County of San Diego Fallbrook Projects – Feasibility Study

3rd Submittal – October 19, 2010

APPENDIX B
Response to Comments

**FIGURE 2
 TYPICAL COUNTY AND LAFCO PROCESSES**

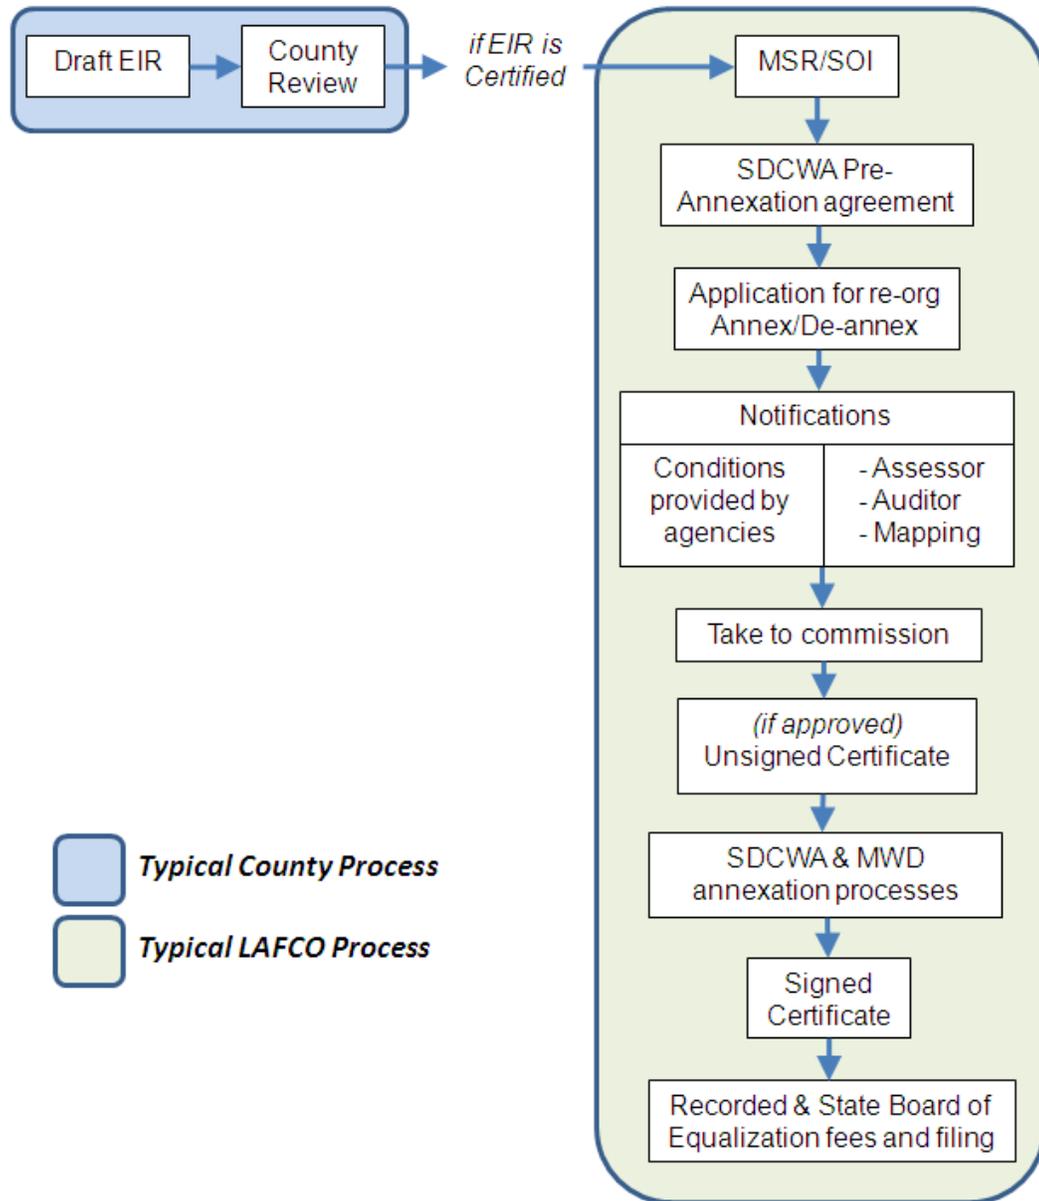
Page 5, Figure 2, note box. *Response: The note box was removed in the text. The meeting minutes attached with the 2nd submittal includes revisions based on LAFCO's review of the draft minutes provided in the 1st submittal.*

Page 5, Figure 2, annexation box. *Response: revised*

Figure 8 **BLACK & VEATCH**
Building a world of difference.

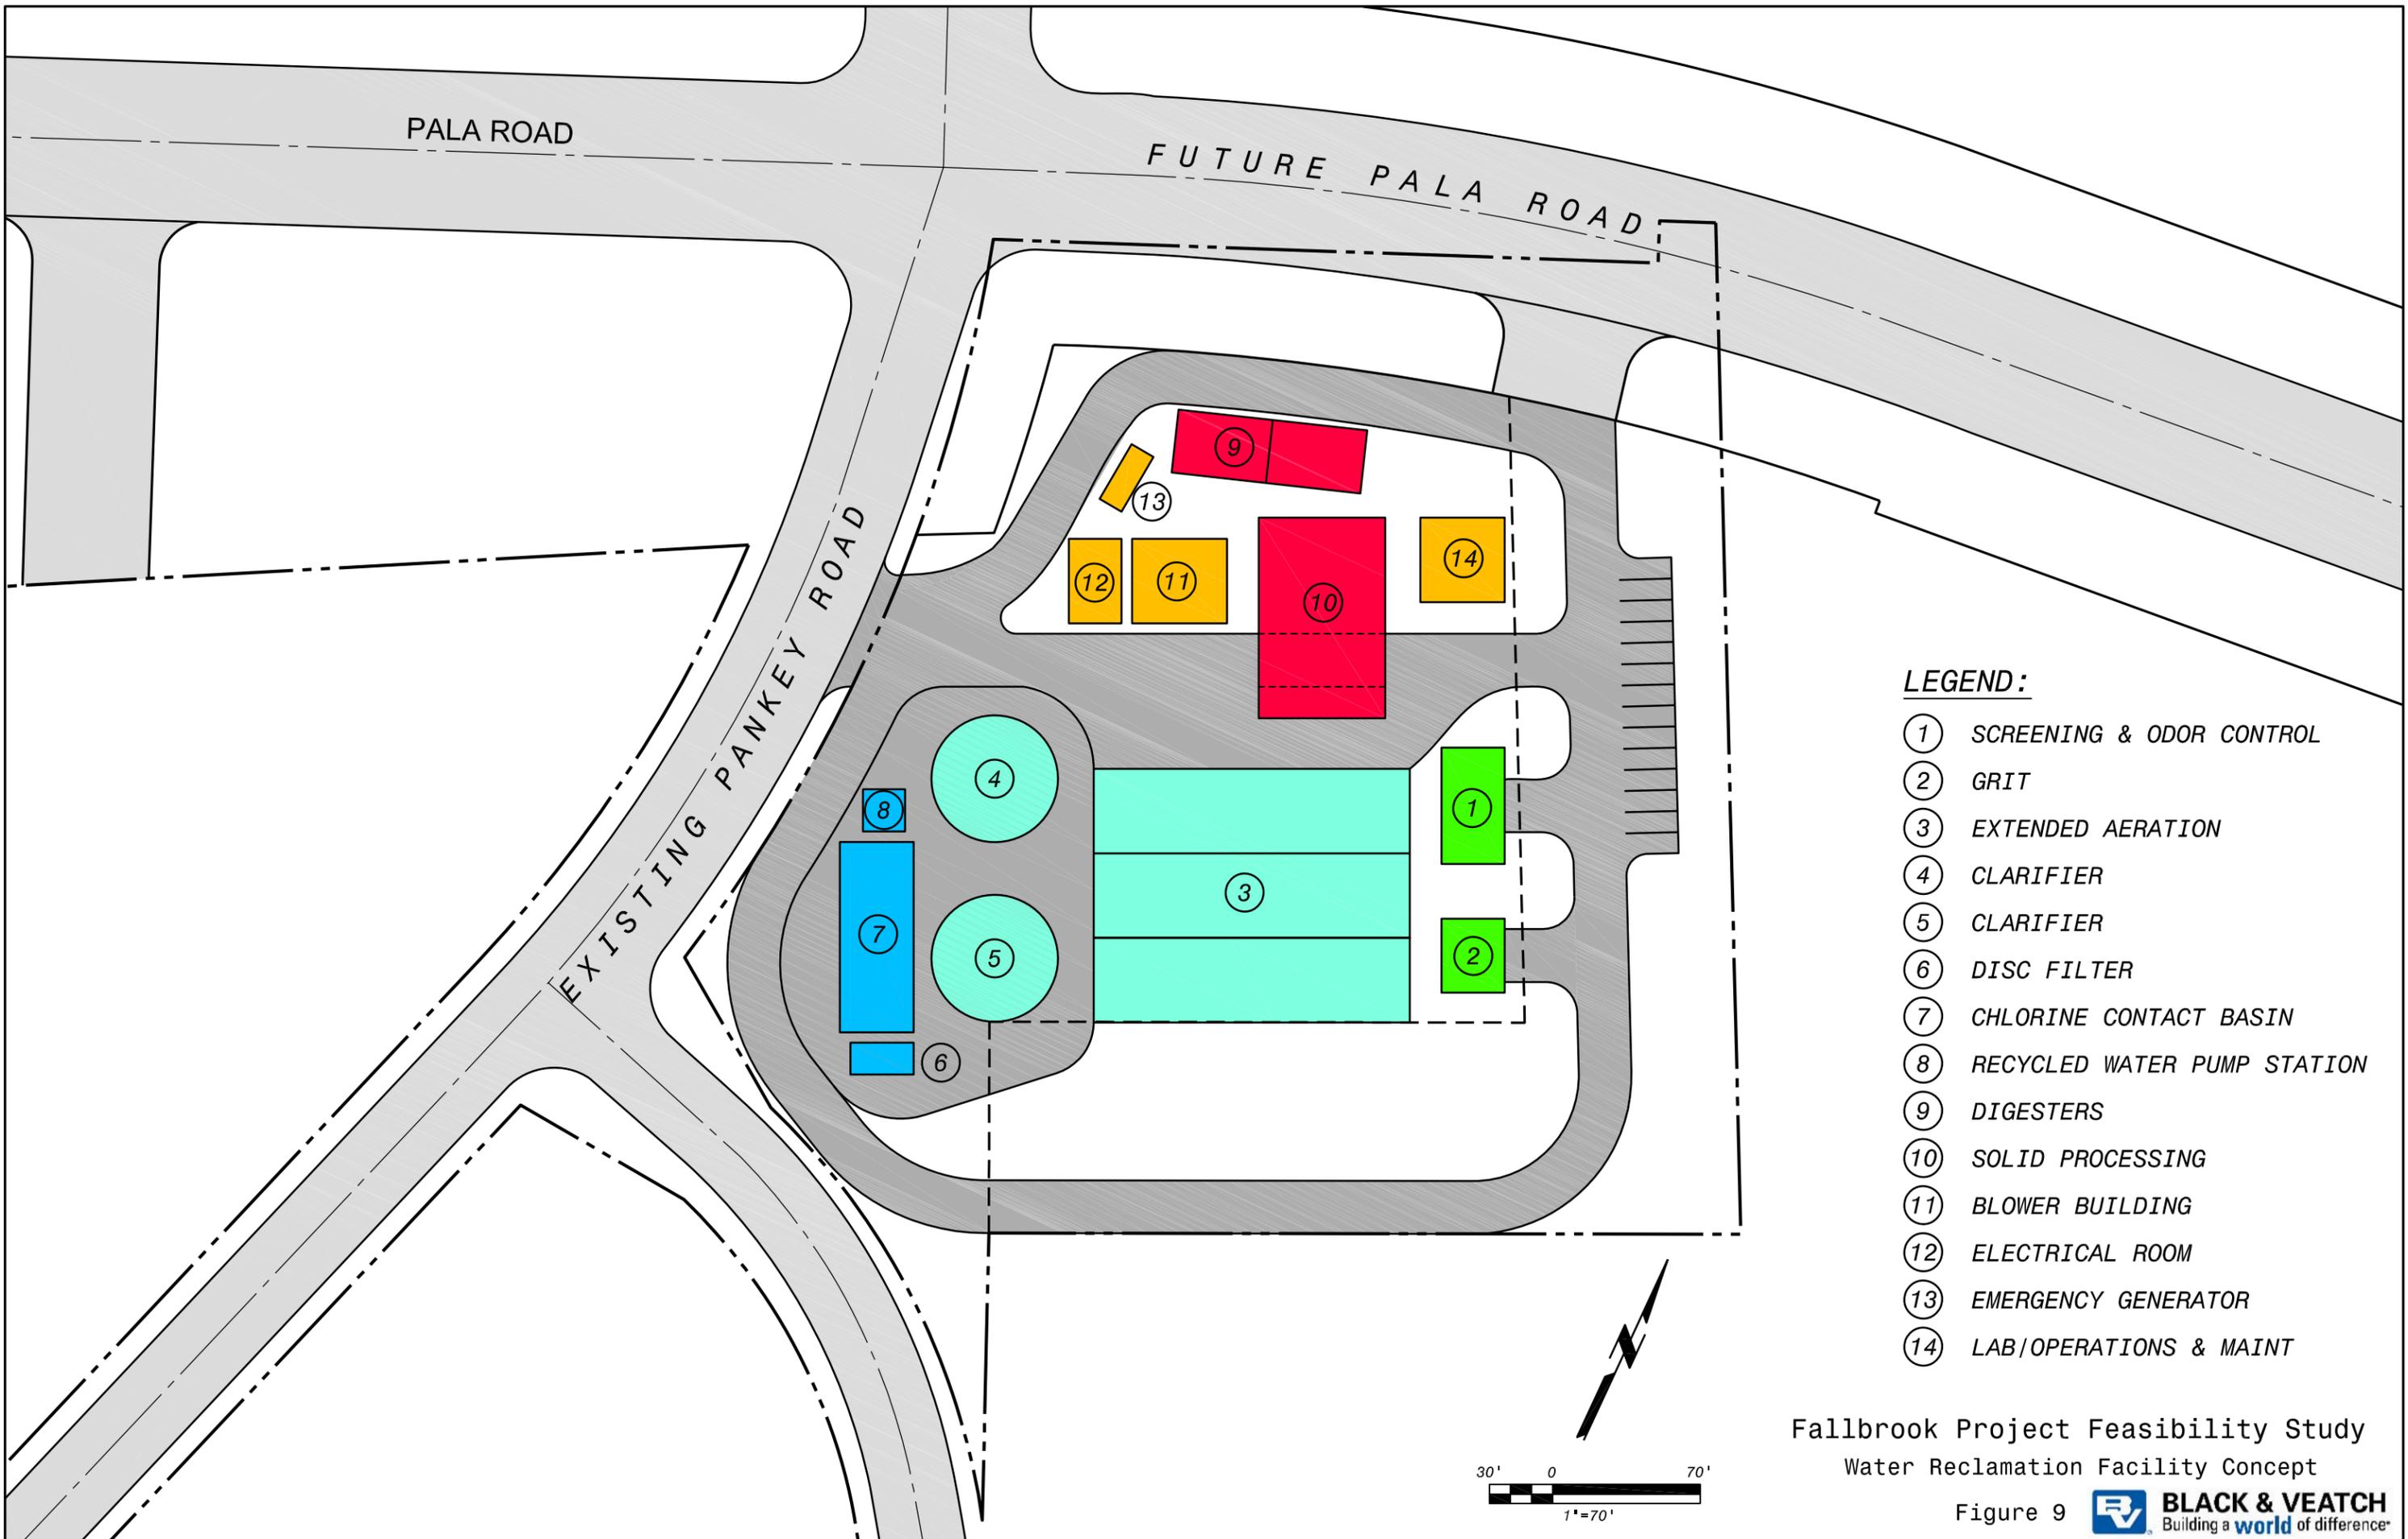
Comment: Note that on Figure 8 the buffer zone appears to be shown for a Meadowood water reclamation site, although there was no mention of it in the text. The shading on Figure 10 should be clarified to more clearly depict which is the 250 feet buffer zone. Also, the buffer zone discussions which we have been a part of were all in the context of a buffer zone to residential uses only. Please confirm that the buffer zone is not required for other land uses.

Response: Figure 8 and 10 include background hatching from the CPW report. We will try and extract that from the graphic in the third submittal. When we met with the VCMWD we understood the buffer to be applicable to all land uses. We will request a clarification from Valley Center regarding this and incorporate into the third submittal if we receive a response in time.
